**EAST GOSHEN TOWNSHIP
PLANNING COMMISSION
Meeting Agenda
Tuesday, October 24, 2023
7:00 PM**

Date: 5-18-2023
To: Planning Commission
From: Duane J. Brady Sr., Zoning Officer
Re: 14 Reservoir Road SD/Glosson

A Preliminary Subdivision Plan entitled "Jeffrey S. & Michelle A. Glosson", prepared by Yerkes Associates Inc., and dated June 1, 2022, and last revised on September 14, 2022, was received by this office on November 18, 2022. This plan is reviewed by the Chester County Planning Commission in accord with the provisions of Section 502 of the Pennsylvania Municipalities Planning Code. We offer the following comments on the proposed subdivision for your consideration.

Site Plan Detail, Sheet 3: Preliminary Subdivision - Jeffrey S.& Michelle A. Glosson

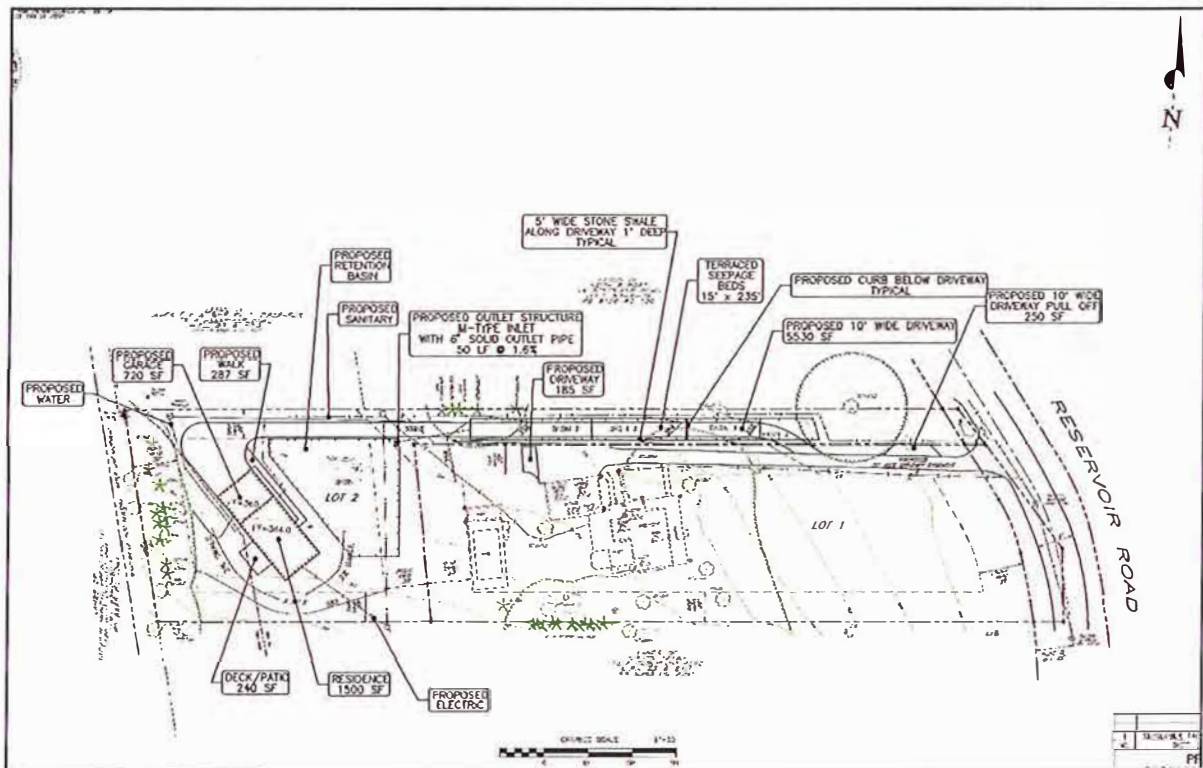
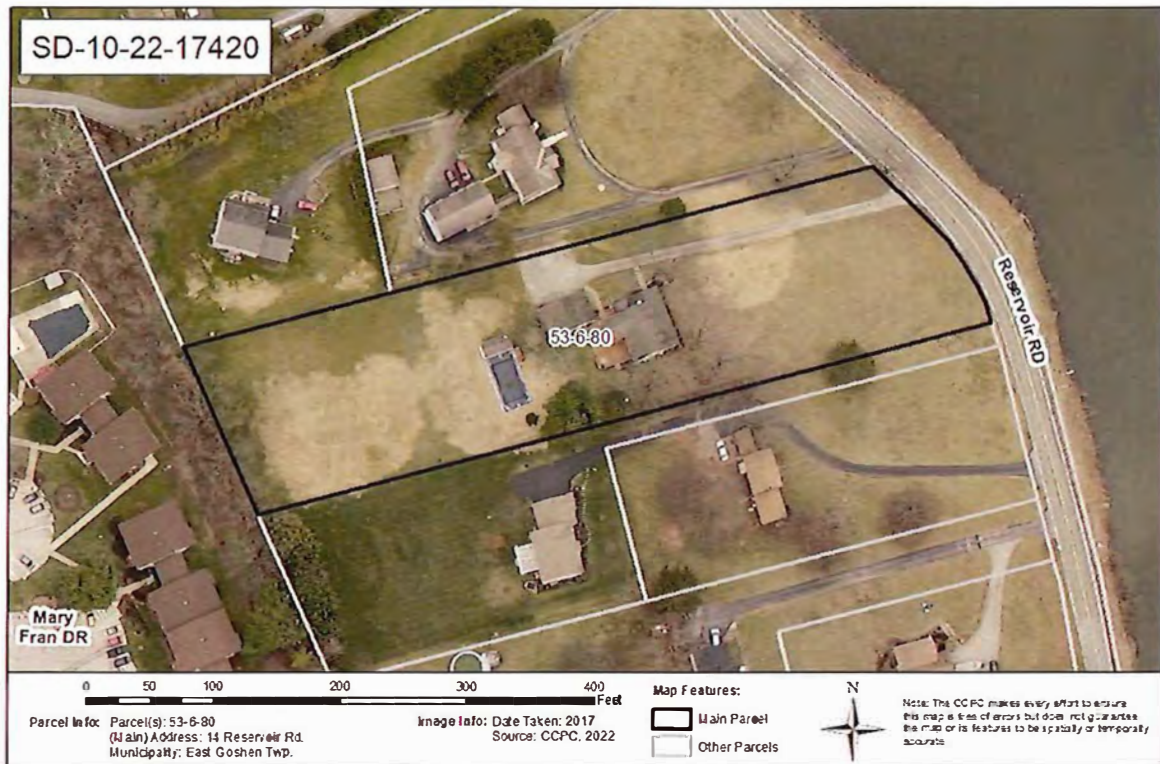
7. Sheet 1 depicts the location of a 20 foot width electric service easement for Lot 1 that is situated on Lot 2. The details of this easement should be incorporated into the deeds of both lots.
8. The site plan depicts the location of a proposed retention basin on Lot 2. Ongoing efforts by the municipality may be needed to educate the homeowner(s) so that they can fully understand and fulfill the operation and maintenance requirements for these facilities.
9. A minimum of four (4) copies of the plan should be presented at the Chester County Planning Commission for endorsement to permit recording of the final plan in accord with the procedures of Act 247, the Pennsylvania Municipalities Planning Code, and to meet the requirements of the Recorder of Deeds and the Assessment Office.

PROPOSED SITE AND STORMWATER MANAGEMENT PLAN

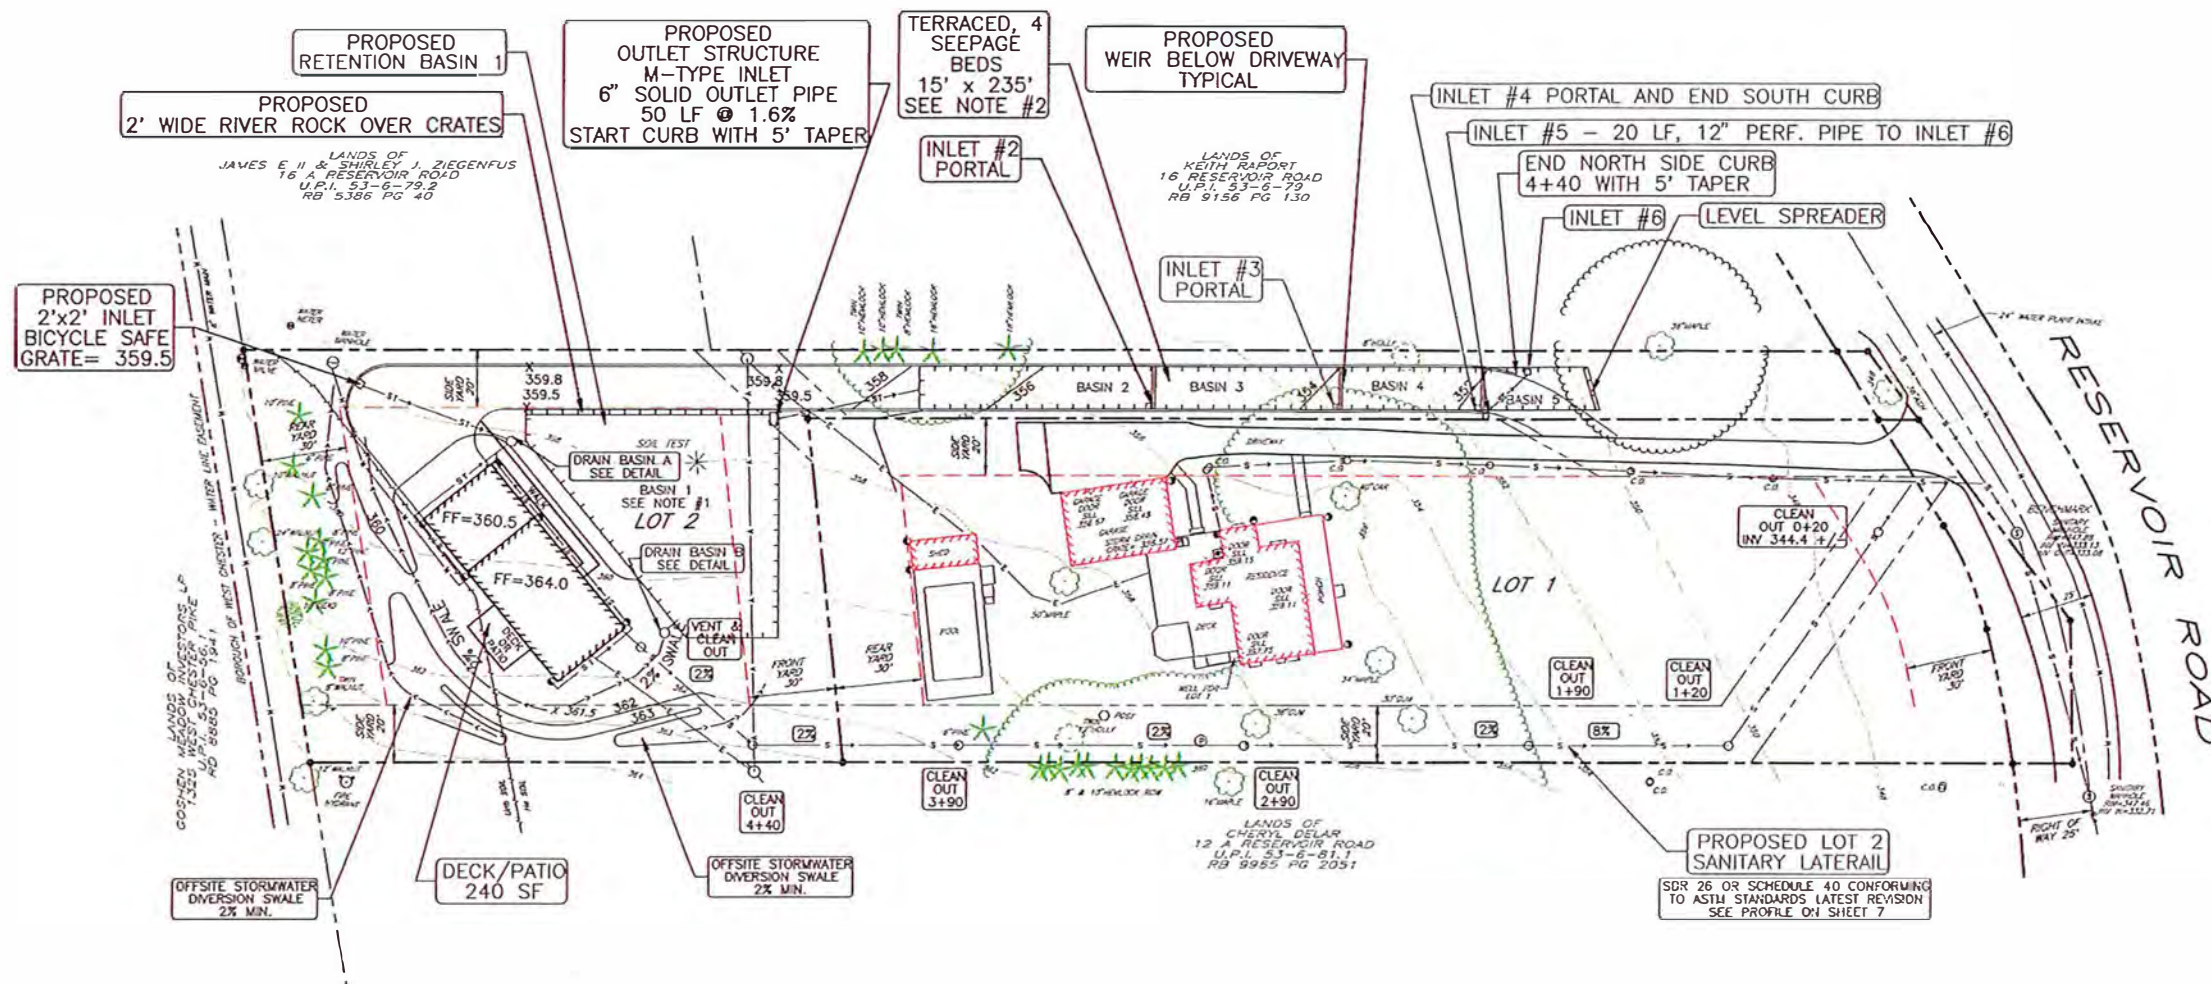
13. A level spreader is proposed for Basin 5; please indicated on the plan and provide a detail, including appropriate permanent erosion controls measures for the discharge.

Outstanding. A detail has been provided but the location is not indicated on the plan.

See sheet 3. level spreader noted at end of basin 5

DRIVEWAY PAVING SECTION OVER BASINS 2 TO 5

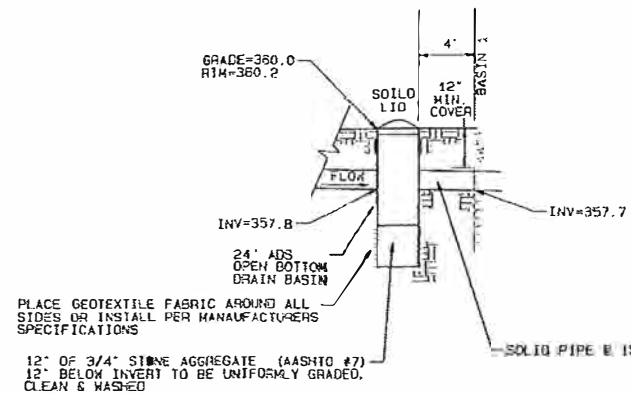
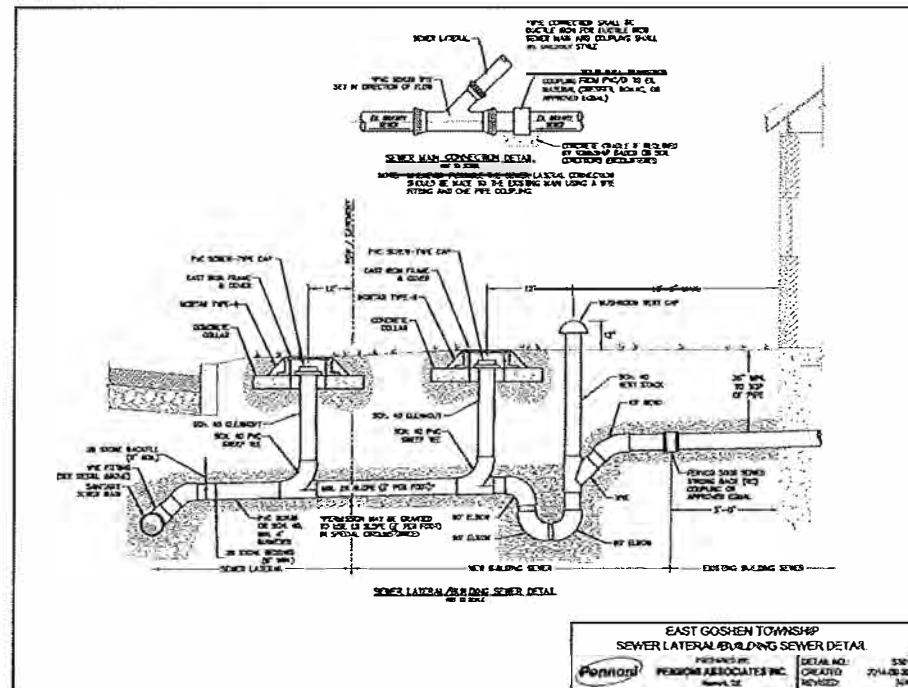
2. Driveway (Fire access road) surface shall be designed and maintained to support the imposed loads of fire apparatus pre IFC 2018 section 503.2.3 Surface. The concern is the stormwater basin installed under the driveway. Plan show basin #2 and #3 could be affected by the apparatus weight. Recommend having information provided from the applicant's engineer that the driveway with the basin install will carry a minimum of 75,000 pounds.
